**Re: Response to EPA Analysis of the *Final Habitat Mitigation and Monitoring Plan*, dated September 12, 2017, EPA Comments October 5, 2017 (Revised November 30, 2017)
Rosemont Copper Project, Clean Water Act Section 404 Permit, CoE File No.: 2008-00816-MB**

RESPONSE TO ENVIRONMENTAL PROTECTION AGENCY (2017)

**"The Mitigation Proposed by Rosemont Mine
Will Not Offset Impacts to Waters of the U.S.
below the Level of Significant Degradation"**

Project Number: 1049.117
January 24, 2018

Figure 7. Sinuosity Measurements on Big Casa Blanca Canyon**Figure 8. Existing Sonoita Creek Sinuosity Measurements**

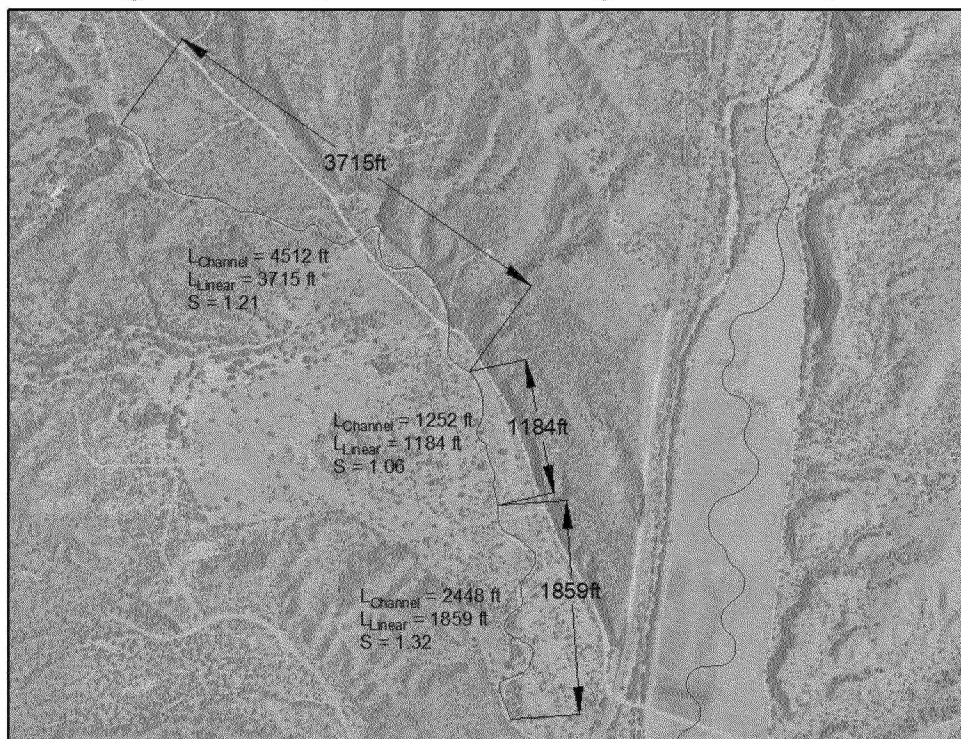
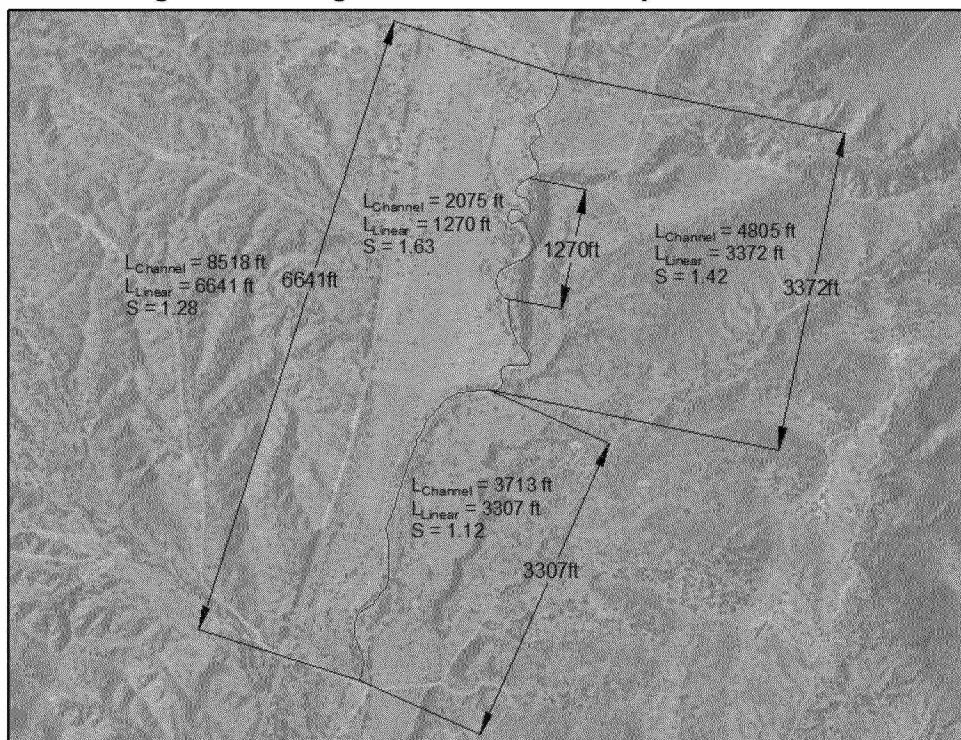
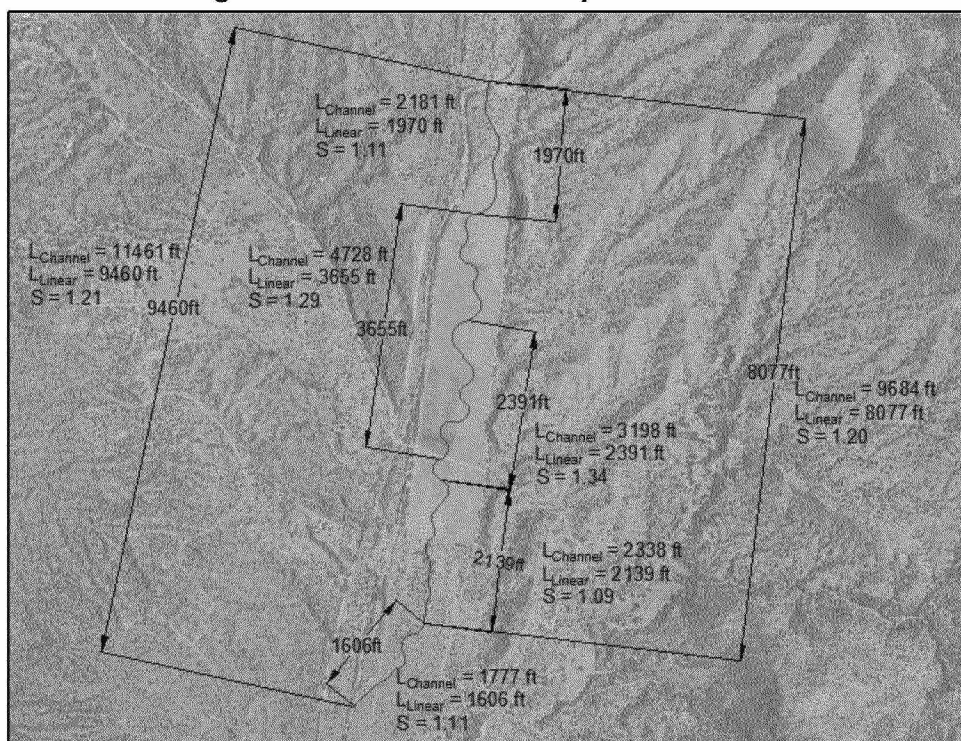
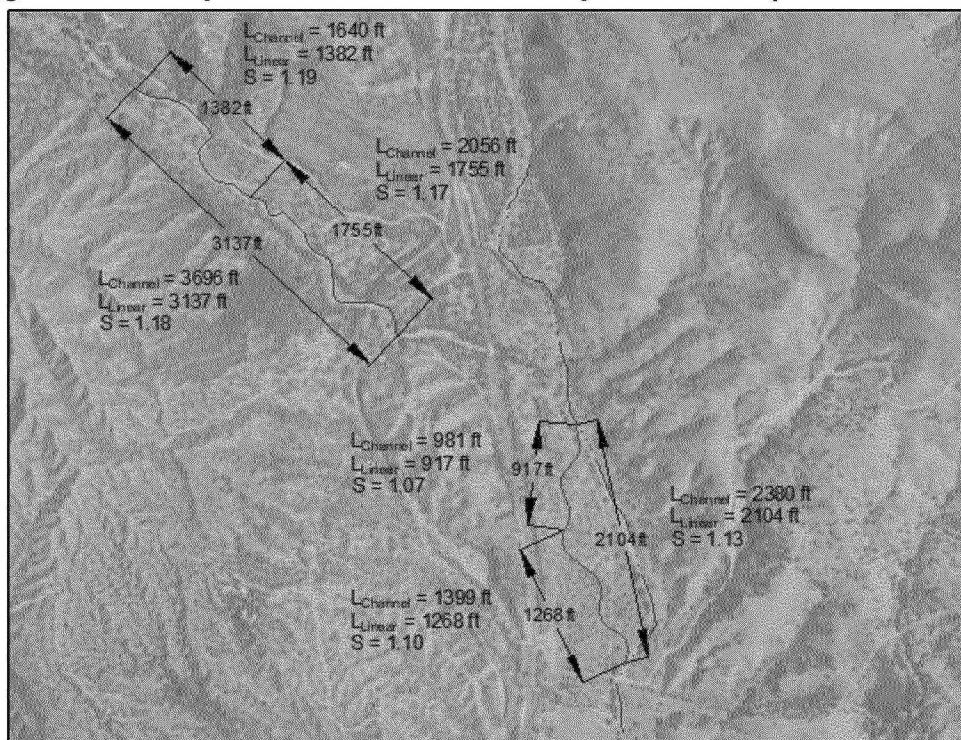
More sinuosity measurements of the existing and proposed configurations of Sonoita Creek are presented for this response than in the HMMP, and they support the design sinuosity as proposed. The least altered, and most functional, dynamic reaches of Sonoita Creek and its tributaries, are not well represented by any single, uniform value of sinuosity, such as the 1.13 value presented by the EPA. Measured sinuosity of the proposed channels is within the measured range of sinuosity for the least-altered reaches of Sonoita Creek, Adobe Canyon, and Big Casa Blanca Canyon (**Table 1; Figures 7 through 10**). Average measured sinuosity of the proposed SCR Channel is 1.21, but the sinuosity measurements range from 1.09 to 1.34 (**Figure 9**), which is within the range of observed sinuosity for existing, functional and dynamic reaches of Sonoita Creek and its tributaries.

The proposed channel planforms are designed with multiple considerations rather than a single measure of sinuosity, and are supported by scientific considerations. The variable sinuosity proposed in the HMMP is better supported by onsite references than a uniform sinuosity value of 1.13 as suggested by the EPA. Furthermore, the dominant sinuosity measured from the inundated surface is 1.13 for the overall SCR Channel, which is equivalent to the sinuosity proposed by EPA, and was not maximized to gain additional mitigation credit.

Figure 11. Dominant Channel Centerline and Active Channel Centerline**Figure 12. Sinuosity Comparison of Dominant Channel and Active Channel**

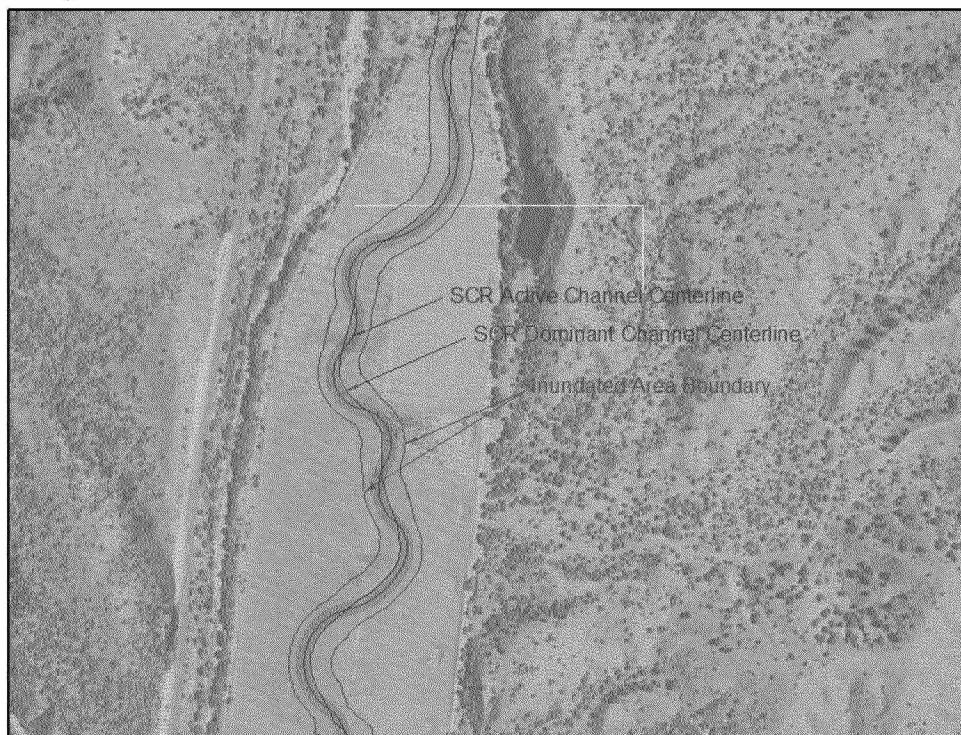
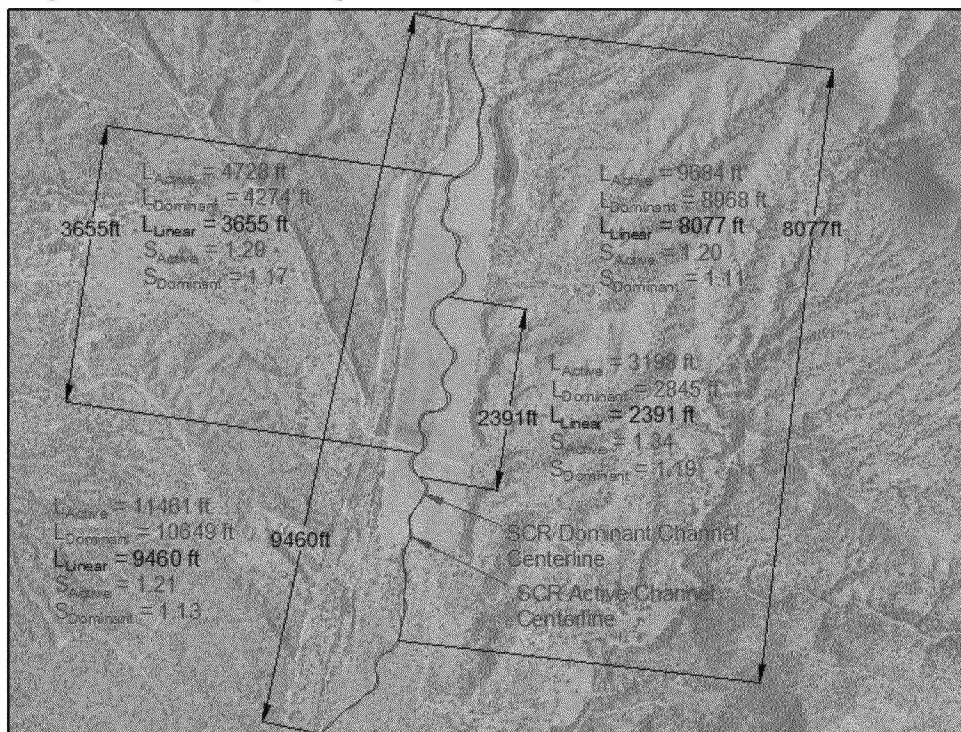
The inundated flow area (i.e., the 5-year flood area and the area for which mitigation acreage was calculated) will have a lower channel sinuosity than the active channel centerline. For instance, that reach of the SCR Channel with a sinuosity of 1.34 as measured from the active channel centerline has a lower dominant sinuosity of 1.19, and the overall measurement of the entire SCR Channel has an active channel sinuosity of 1.21, and a dominant sinuosity of only 1.13 (**Figure 11**). This approach demonstrates that sinuosity was informed by scientific and engineering principles rather than an attempt to maximize mitigation credit.

Figure 13. Walnut Gulch at Flume 6 and Downstream

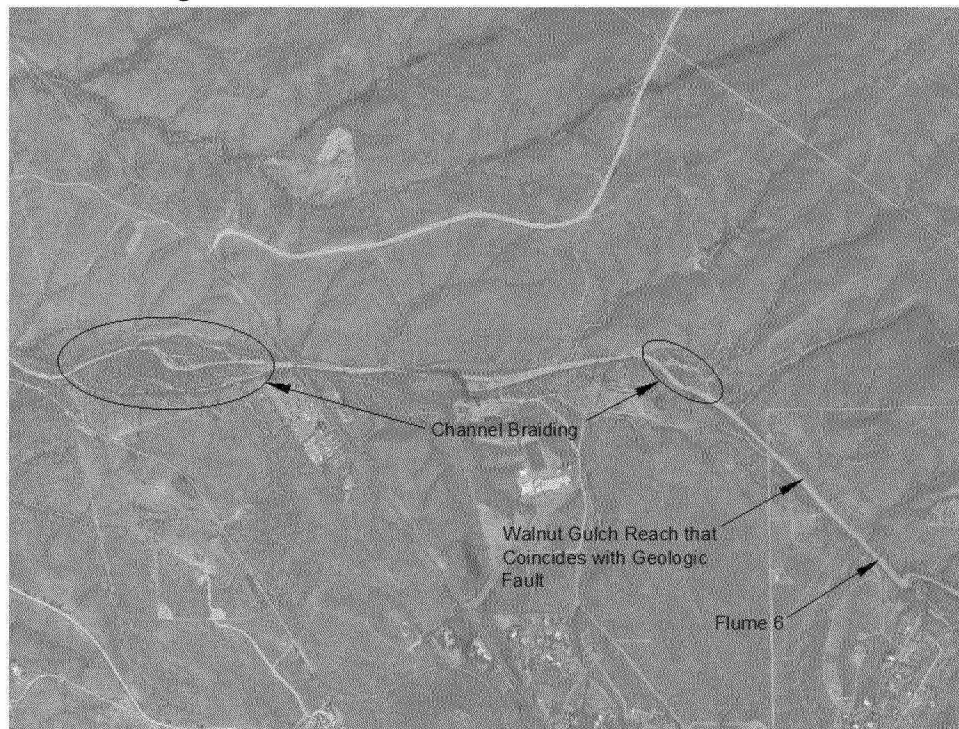
The EPA (2017) states that the HMMP (Exhibit 1) depicts Walnut Gulch from Flume 7 to Flume 1 and further states that Walnut Gulch does not exhibit any braiding patterns between Flume 6 and Flume 2, which demonstrates that Sonoita Creek will likely not exhibit any braiding patterns. The EPA also notes that the reach from Flume 7 to Flume 1 has significantly greater watershed area, tributary inputs, and channel dimensions than the upstream reach between Flume 2 and Flume 6.

The HMMP (Exhibit 1) depicts Walnut Gulch between Flume 2 and Flume 1 as well as downstream of Flume 1, and depicts a tributary to Walnut Gulch at Flume 7. The majority of channel braiding occurs along this reach of Walnut Gulch; this is not the same reach for which hydrologic analyses were conducted and results compared with recurrence intervals and peak flows from the SCR mitigation project. As described in more detail elsewhere, the reach near Flume 6 was identified as most like the SCR design watershed for hydrologic analysis, with its similar watershed area and elevation. However, the reach near Flume 6 at Walnut Gulch has important physical differences from the SCR mitigation project site. Specifically, Walnut Gulch near Flume 6 flows through a narrower valley with more physical constraints that limit channel migration and sinuosity more than the unconstrained physical conditions at Sonoita Creek. The straight reach of channel downstream of Flume 6 is coincident with a geological fault line and is confined by geologic controls, and therefore should not be used as a reference reach for sinuosity to apply to Sonoita Creek. Nevertheless, there is some braiding between Flume 2 and Flume 6 (**Figure 13**).

Figure 15. Sonoita Creek Constrained Between Highway 82 and Gas Pipeline

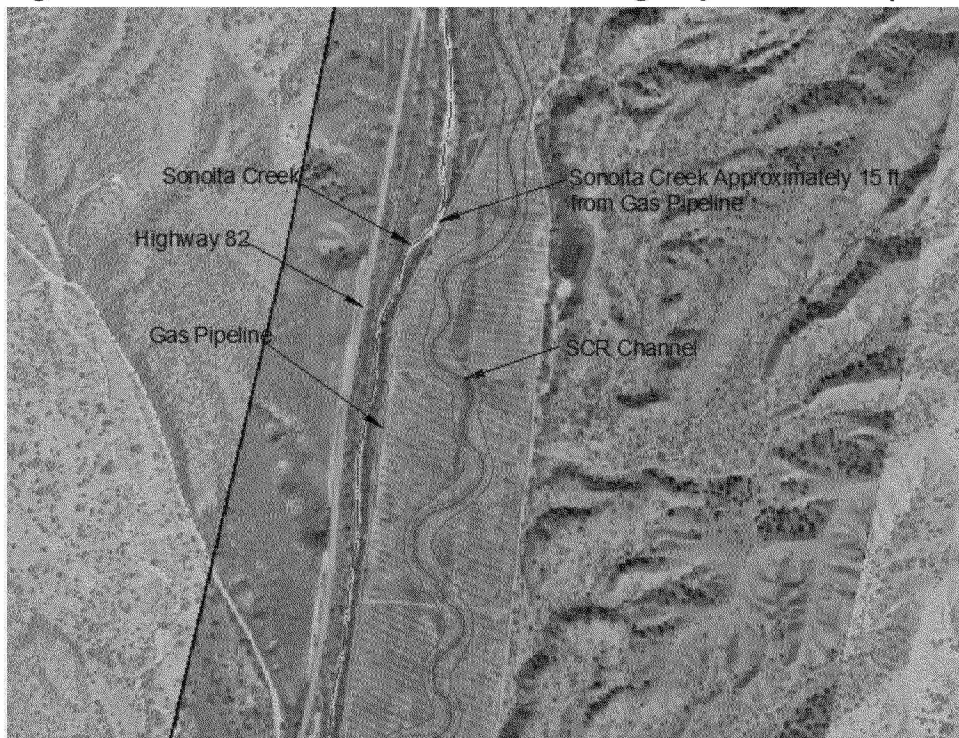
Finally, the EPA suggests that existing Sonoita Creek at SCR could be rehabilitated by excavating portions of the floodplain along its eastern bank.

This approach is not feasible at SCR because the gas pipeline is parallel to and in close proximity to the current eastern channel bank, in one case as close as about 15 feet (**Figure 15**). Furthermore, rehabilitating only the eastern bank would still leave in place the existing west bank, constrained by the highway and significantly manipulated and degraded by concrete channel walls and gabion baskets. The majority of the artificial armoring, which precludes channel migration or development as well as access to a functional floodplain, is located at the existing west bank at SCR.

Regarding excavation of portions of the floodplain along its eastern bank, for the majority of the existing Sonoita Creek reach located at the SCR Ranch, we note the following:

- There simply is not adequate space to rehabilitate the eastern bank to provide significant ecological benefit;
- The degraded and manipulated west bank will continue to limit functions including: flow access to floodplain, energy dissipation, development of an ecologically functional riparian zone with diverse and/or robust vegetation and wildlife habitat;

Figure 16. Bank and Buffer Rehabilitation at Lower Sonoita Creek

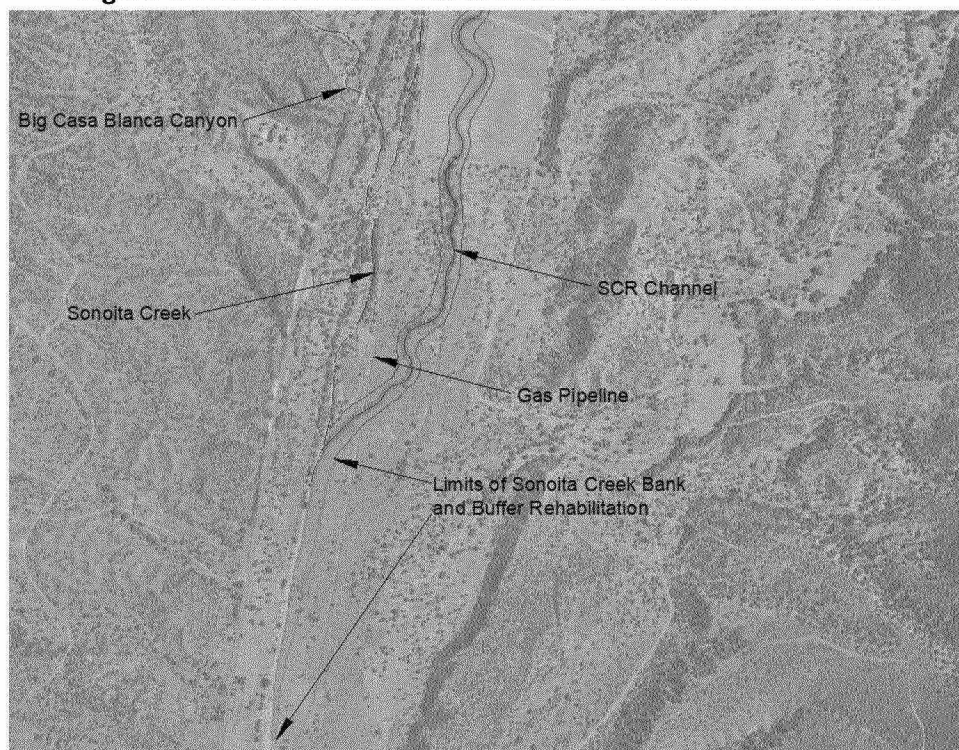
The EPA (2017) discourages the SCR mitigation project component that includes bank and buffer rehabilitation along the eastern bank of a reach downstream of the major channel rehabilitation reaches. The letter discounts channel bank sloughing and erosion as normal conditions and suggests that Sonoita Creek's channel banks be allowed to erode towards an equilibrium state characterized by a high-functioning floodplain.

This comment is notable in that it directly contradicts the EPA's comment in the immediate preceding paragraph, wherein they recommend rehabilitation along the eastern bank of the existing Sonoita Creek. Bank and buffer rehabilitation along the eastern bank is not practical for Sonoita Creek throughout the majority of SCR because there is not enough space between Sonoita Creek and the gas pipeline. However, bank and buffer rehabilitation is feasible along lower Sonoita Creek (as opposed to backfilling and replacing Sonoita Creek) because there is sufficient space, generally 330 to 350 feet, between lower Sonoita Creek and the gas pipeline (**Figure 16**).

Figure 17. Effect of Elevated Roadway on Tributary Flowpaths

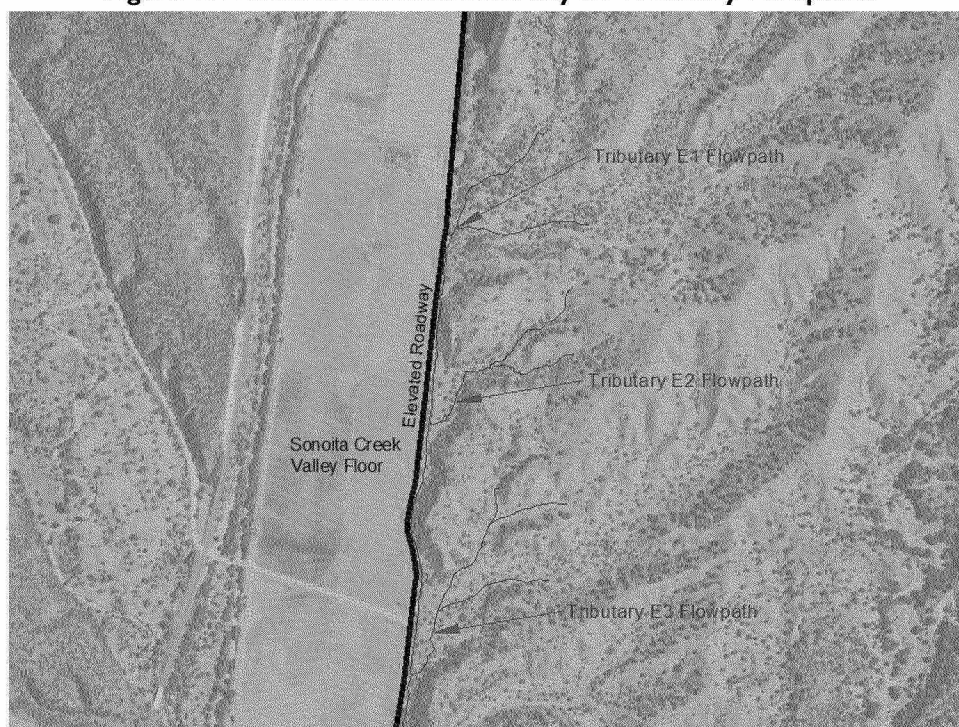
The EPA (2017) further asserts that the access road on the eastern edge of the agriculture field does not block the flows from the three tributaries. In response, we note that the access road was constructed as a linear fill across the eastern valley edge that is generally 4 to 5 feet higher than the existing terrain to the east. There are no culverts to convey discharge from the eastern tributaries under the road into the Sonoita Creek valley. The access road clearly interrupts flow and sediments from the three tributary channels based upon observations during field investigations (**Figure 17**). Sonoita Creek at SCR is a valley fill that was created as a result of sediments from the tributary watersheds being conveyed into and deposited on the valley floor. The HMMP proposal to reconnect the three eastern tributaries to the SCR Channel will reestablish natural continuity for stormwater hydrology and sediment transport into the Sonoita Creek valley. Furthermore, reestablishment of even small ephemeral drainages such as these will result in a more diverse and natural ecological condition. Therefore, reconnecting the three tributaries will provide substantial ecological benefit for the eastern side of the valley in that area.

The EPA (2017) finally states that there is not sufficient stream power to form a permanent bed and bank channel for the three tributaries. A defined bed is already observed where the roadway interrupts natural flow and diverts stormwater south along the road fill, and there are defined beds for each tributary upstream of the area where they currently terminate. It is speculative to suggest that the channel bed and bank features of the three reestablished connections to Sonoita Creek will recede over the long-term. Even if they do, eliminating the elevated roadway will reestablish the natural drainage pattern for stormwater and sediment to enter the Sonoita Creek valley with associated ecological benefits.

Exhibit 5. Average-Annual Runoff Regression from Stone et al. (2008)

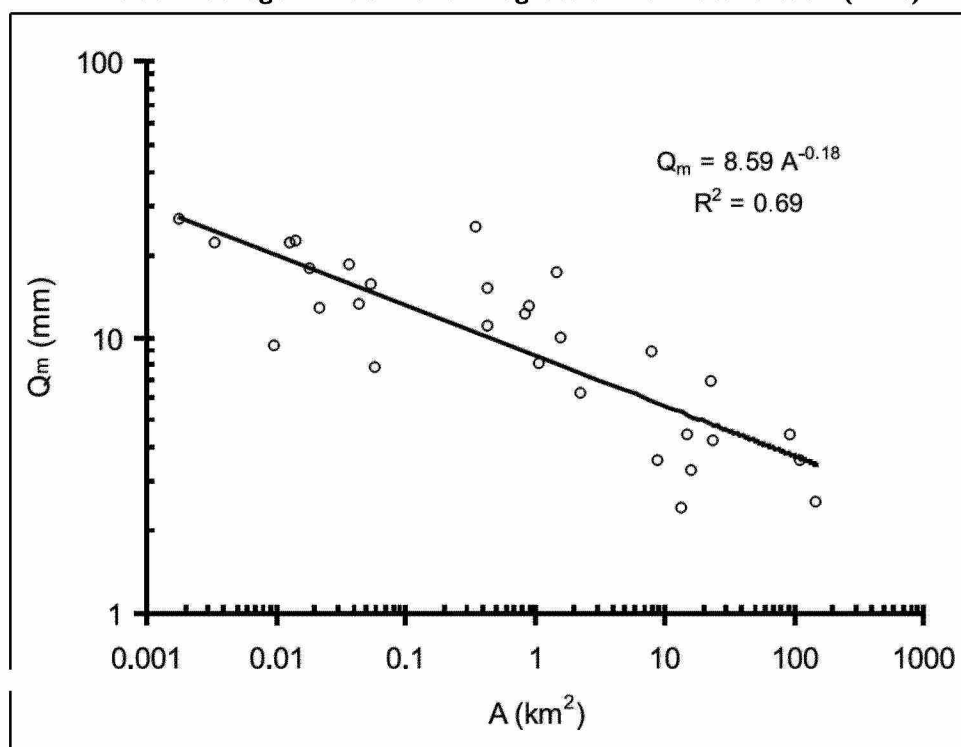
The EPA (2017) has expressed concern relating to the revised pre-mining and post-mining estimates and has questioned the validity of the methodology: “*The estimates of average-annual runoff rely on an inappropriate model/ regression equation. The regression equation can only apply to the limits of the data. A continuous simulation model with daily time steps would be more appropriate. A regional model such as a SWAT-based model that is localized with smaller resolution grids is an example of such an approach.*” This observation is flawed, however, because it is not the resolution or time step of the model that is of primary importance, but rather the relative comparison between the modeling results (i.e., modeled pre-mining flows vs. modeled post-mining flows). The EPA’s assertion, that a continuous simulation model with daily time steps is

However, before such a demonstration is presented, the following additional information is provided regarding the actual runoff that discharges from the Rosemont watershed. In 2008, Stone et al. (2008) collected and analyzed average-annual runoff volumes that were collected from streamgages on the Walnut Gulch and the Santa Rita Experimental watersheds, both located in southern Arizona and in close proximity to the Rosemont watershed. Using the runoff data, which was collected as early as the 1950s, Stone et al. (2008) developed a regression equation to estimate average-annual runoff based on watershed area. This equation is presented in **Exhibit 5** and compares average-annual stormwater runoff per unit area to the size of the catchment area.
